Access Compliance Report

Public Rights-of-Way

(Curb Ramps)

Intersection ID: 27440	Main Street: BALLANTYNE COMMONS PY	Cross Street: DOWINGTON DR	Location:	SW
ADA ID: D45001334F2B	Ramp Type: Perp	Initial Pass/Fail: Fail	Overall Compliance: No	Severity Score: 10
Codes/Mitigation Info/Possible Solution		Field Measurements/Component Compliance

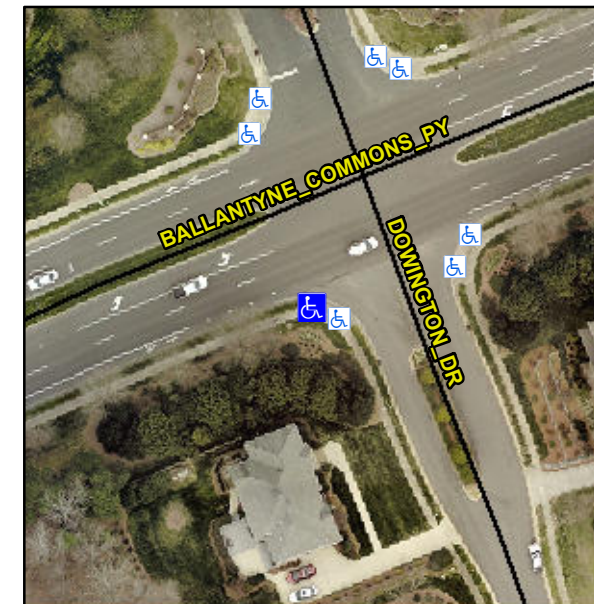
Not Found, R304.5.1, R304.5.3

Compliance	Description	Data	Compliance	Description	Data
N/A	Ramp Length (in)	107.0	Yes	Ramp Slope (%)	5.4
No	Ramp Width (in)	37.5	No	Ramp XSlope (%)	3.0
N/A	Flare Type LT	N/A	N/A	Flare Type RT	N/A
N/A	Flare Slope LT (%)	N/A	N/A	Flare Slope RT (%)	N/A
N/A	Flare Traversable LT?	N/A	N/A	Flare Traversable RT?	N/A
N/A	Landing Length (in)	N/A	N/A	DWS Provided?	N/A
N/A	Landing Width (in)	N/A	N/A	DWS Contrast?	N/A
N/A	Landing Slope (%)	N/A	N/A	DWS Length (in)	N/A
N/A	Landing X Slope (%)	N/A	N/A	DWS Full Width?	N/A
N/A	Landing Curb? (Y/N)	N/A	N/A	DWS Offset (in)	N/A
N/A	Shared Landing?	N/A			
N/A	Gutter Ponding?	N/A	N/A	Gutter Slope (%)	N/A
N/A	Gutter Lip Ht (in)	N/A	N/A	Gutter X Slope (%)	N/A
N/A	Painted X Walk1?	No	N/A	Painted X Walk2?	N/A
	X Walk 1 Direction	To N		X Walk 2 Direction	N/A
N/A	X Walk 1 Width (in)	N/A	N/A	X Walk 2 Width (in)	N/A
	X Walk 1 Slope (%)	2.7		X Walk 2 Slope (%)	N/A
	X Walk 1 X Slope (%)	2.9		X Walk 2 X Slope (%)	N/A

Remove & Replace Entire Ramp.
